Entergy Operations Inc.
River Bend Station
5485 U.S. Highway 61N
St. Francisville, LA 70775

SUBJECT: NRC INITIAL EXAMINATION

RB-2019-11, Written Exam Analysis

Question 16, 2/13 missed (15%)

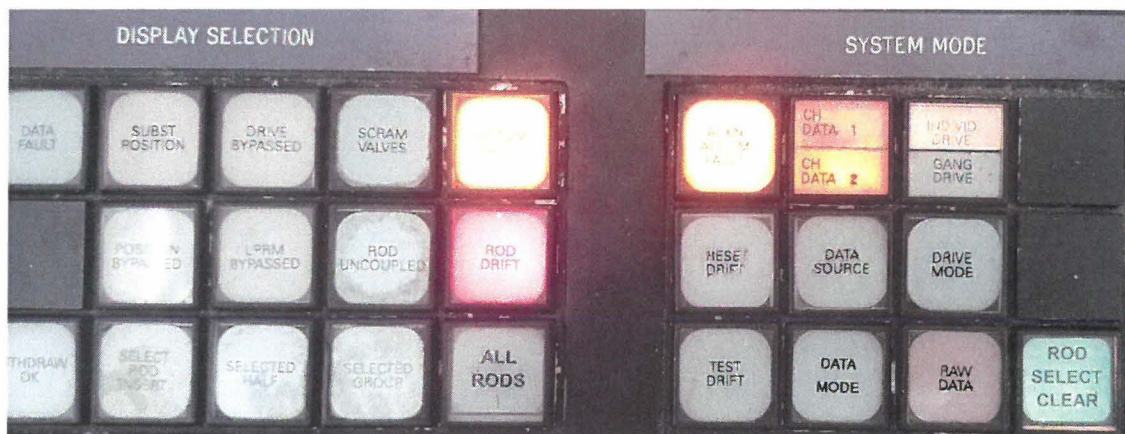
This question was missed due to students understanding of operation of MOV powered by E22-S004, Div 3 4160KV Bus. When E22-MOVF004, HPCS Injection Valve is closed the motor to operate the valve is energized causing load currents on the bus to increase due to additional electrical loading.

Based on additional electrical loading to operate the E22-MOVF004, RBS believes B & D should both be acceptable correct answers.

Photos: RAW DATA Deselected, Full Core Display indicates 00 for each rod.

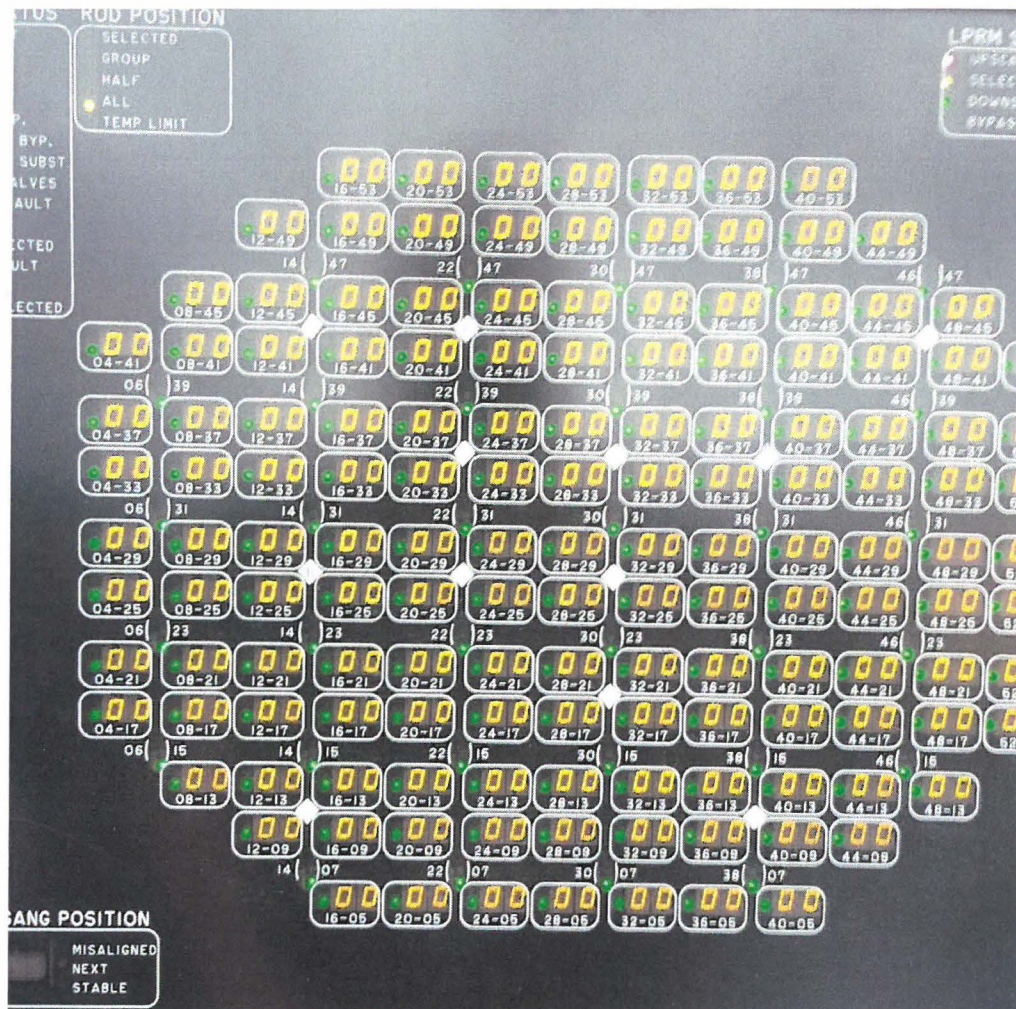
During simulator training, the students were taught to use both methods (RAW DATA selected and deselected). When raw data is selected the position will indicate - - . When raw data is deselected, and all rods is depressed 00 will be indicated on the full core display. See photos for illustration. The students were trained to use both methods to verify all control rods are fully inserted.

Based on the training provided and simulator performance answers A and D should be correct answers.
